Lebanon Fish Counters

Wednesday, August 18, 2020 2:00 PM

Agenda Topics

South Ladder Design Options 1 & 2 Sketch

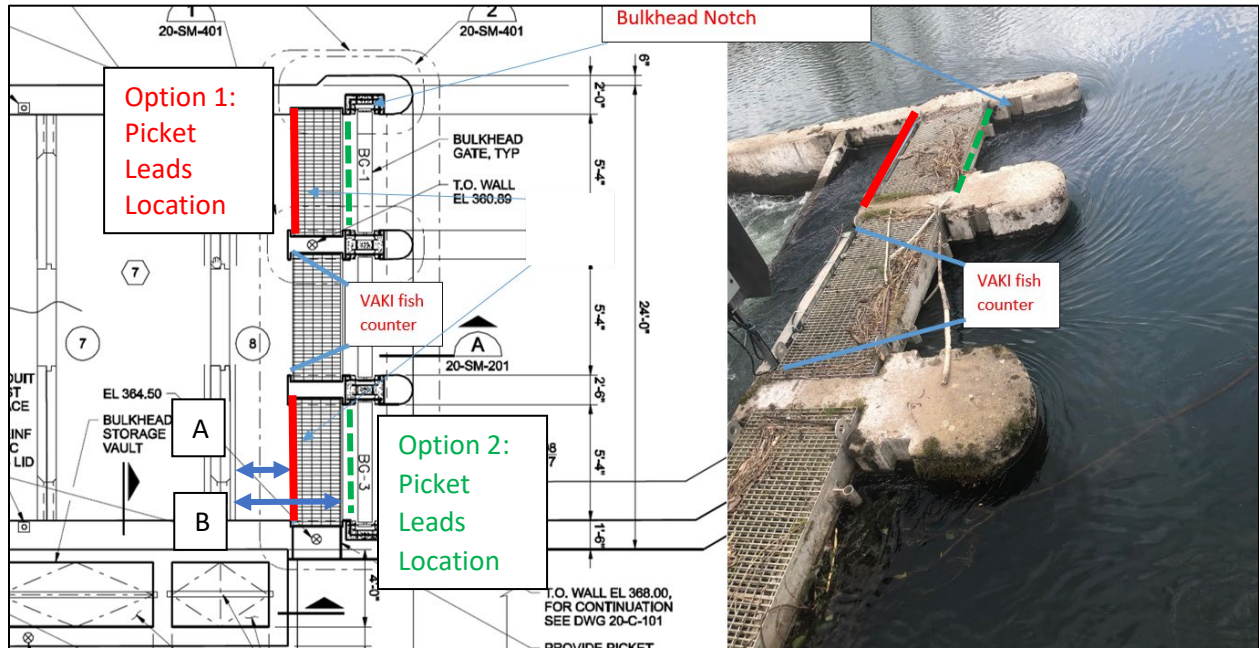
- a. **Option 1:** Red lines denote the picket leads, installed immediately downstream of the grating. Double-arrow A denotes distance between upstream Weir 8 face and downstream picket lead face, distance of 3'.
 - i. **May be just too close.**

- ii. Fallback may be an issue for Options 1 and Options 2 (Fish makes all the way up, needs to find center channel, hits obstacle and they drop back) this is seen at Bonneville a lot.
- b. **Option 2:** Same as option 1 except picket leads (shown in green dashes for this option) are installed immediately upstream of the grating and immediately downstream of the bulkhead slots. This gap is approximately 9.5". Double-arrow B denotes distance between upstream Weir 8 face and downstream picket lead face, distance of 5' 10". Would require cutting of the vertical pipe holders currently occupying the gap.
- c. Option 3: Vaki Riverwatcher is placed outside of fishway with picket lead acting as a funneling structure for fish passage through the counter and as a passive debris block via river current. Riverwatcher would likely sit on a platform and be attached to the wall face.

South Ladder Design Option 3 Sketch

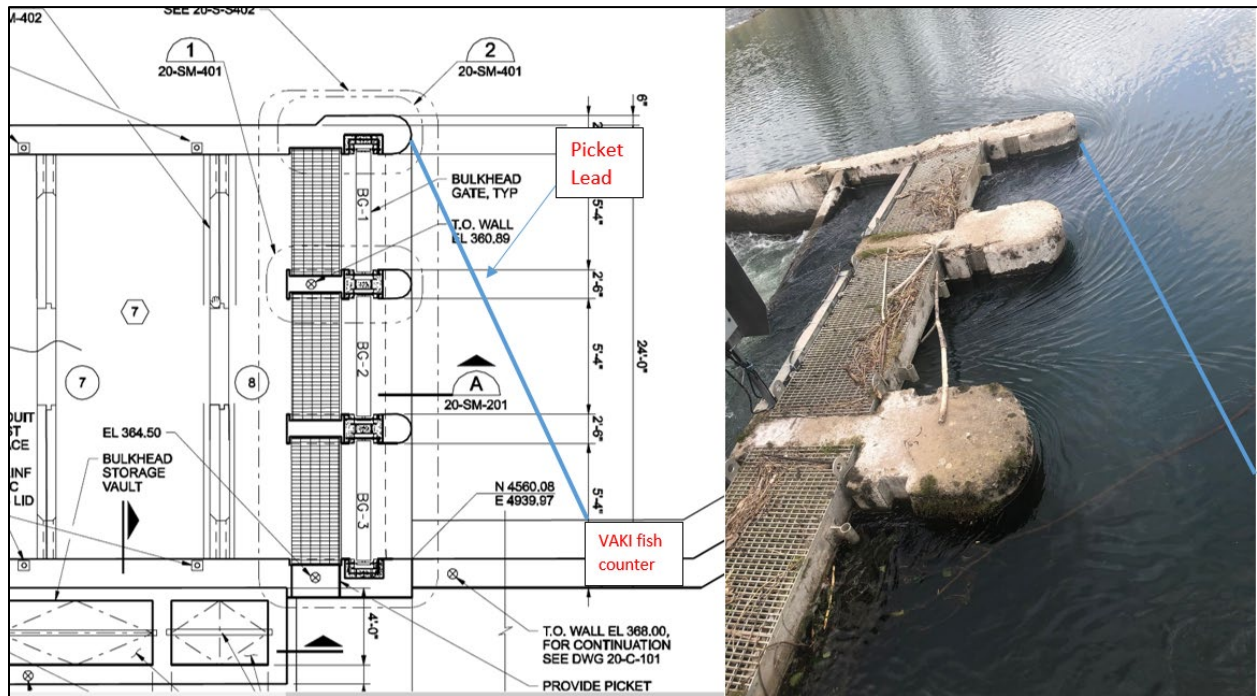
- i. May need a column or supports due to length, as there is a lot of load on a 30' stretch
- ii. Would need to be more stout
- iii. Get dimension between lead and the second pier
- iv. Picket lead would also need to be better supported
- v. Need a concrete base for the picket leads
- vi. Would like to have velocities as well
- vii. Picket leads getting plugged will change the hydraulics so boom may be necessary
- viii. How would this be maintained?
- ix. Would debris actually get carried away given the flow dynamics of the structure?
- x. Could move the fish counter up a bit and leverage a better angle as a result.

South Ladder Design Option 4 Sketch

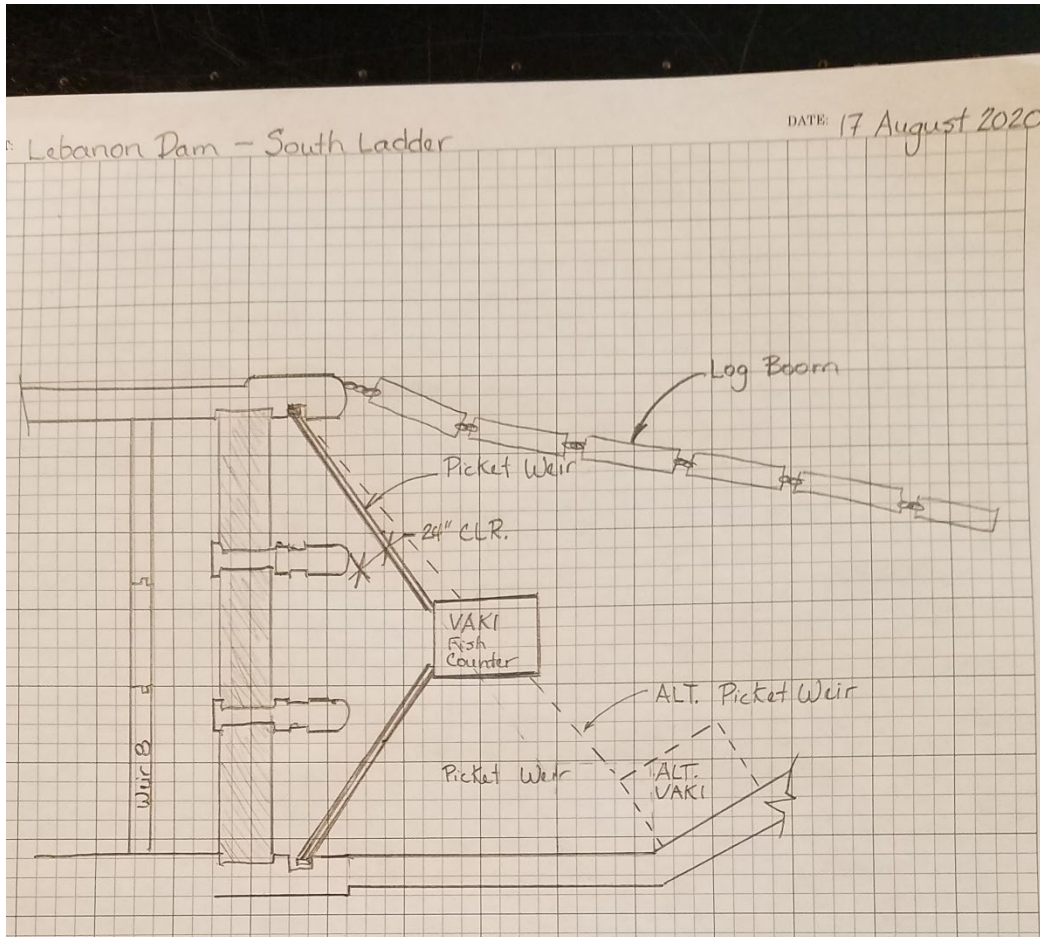
- d. Option 4: Bulkhead notches used to secure picket weir with Riverwatcher sitting on top of an anchored platform.

- a. Log boom would be pretty important in any alternative.
- b. Preferred guidance approach, funneling is standard. Better flow conditions as well, but the alternate form is also acceptable in Joel's opinion.
- c. Mehdi comments on this asking for depth; says we need an investigation on the substrate to support on the column. Could be more difficult.
- d. Joel approves using existing concrete structure as part of the support system
- e. 24' from pier nose to Vaki when mounted on the wall.
- f. More upstream would have lower velocity and would help with the cleaning
- g. Are there less stout picket leads that wouldn't require post and concrete foundations? More flexible options? Would this be alright if we have to remove the counter seasonally?

Figure 4 Example of typical VAKI install(Left). "Funnel" and crowder box (circled) could potentially be mounted on the North Bank Ladder(right).

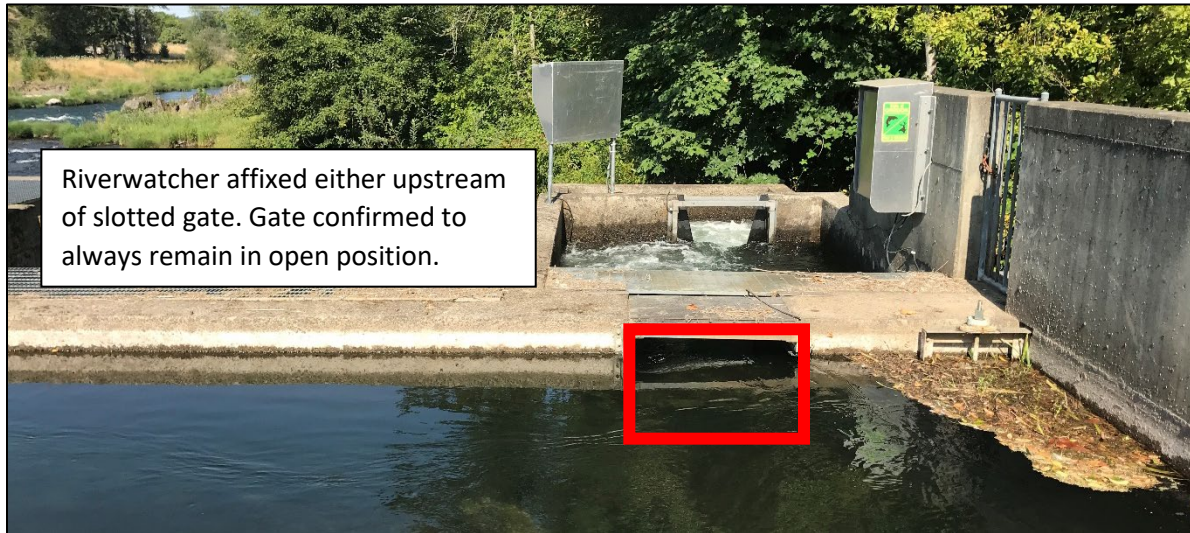
2. Design Options for North Ladder
